**SUBJECT:**  
Modification of the Final Environmental Design Plan for  
Tailrace Design Changes, including  
Restoration and Mitigation  
FERC # P-11659

On September 13, 2005, FERC issued an Order Modifying and Approving Final Environmental Design Plan Pursuant to Article 401 of Gustavus Electric Company's Hydropower License, P-11659 for Falls Creek. This plan included under paragraph (1), the final location of the powerhouse and tailrace to reduce effects on anadromous fish and their habitat. The approved plan was assembled in consultation with and agreement of all interested resources agencies. This plan included a shorter tailrace due to concerns of slope failure along the canyon walls.

**FALLS CREEK HYDROELECTRIC PROJECT**  
**FINAL TAILRACE LOCATION PLAN -**  
***INCLUDING RESTORATION AND MITIGATION***  
Prepared by Bob Christensen - Environmental Compliance Monitor  
12/11/2006

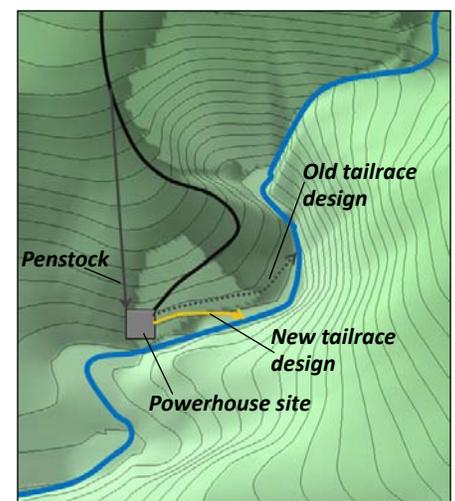
**Modifications of the tailrace design** - The present design plan calls for extending a tailrace approximately 500' upstream of the powerhouse to a point near the upstream extremity of spawning habitat. This installation would require the removal of the largest remaining spruce trees in the area and destabilize the forested uplands, very likely resulting in failure of the slope that currently maintains the last major remnant of high quality bear and murrelet habitat in this portion of the canyon. To avoid this, we recommend shortening the tailrace so that remnant forest patches are not further disturbed. This change may, however, dewater a portion of the suitable spawning habitat upstream of the powerhouse at very low flow periods.

**The minimal action alternative** would include all slope stabilization measures deemed necessary and would shorten the tailrace length to approximately 300'. The in stream conditions would be left as is. Under this scenario we expect these effects:

*Schematic for ELJ alternative.*

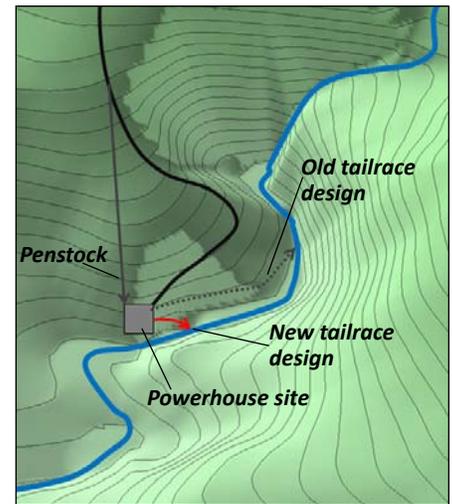
**The engineered logjam alternative** would include all slope stabilization measures deemed necessary and would shorten the tailrace length to approximately 150'. In addition, the logjam area would be engineered and reconstructed to result in:

1. restoration of island-logjam habitat impacted by October landslides;
2. long-term maintenance of logjam habitat through a "permanent" anchor system;
3. minimize net loss of suitable spawning habitat upstream of the tailrace outflow,
4. development of rearing habitat (pools) in the channel west of the island; and,
5. control of gradient and flow to insure natural bedload throughput, reduce the likelihood of a velocity barrier to fish passage and protect the stream bank in immediate vicinity of powerhouse facilities from erosion.
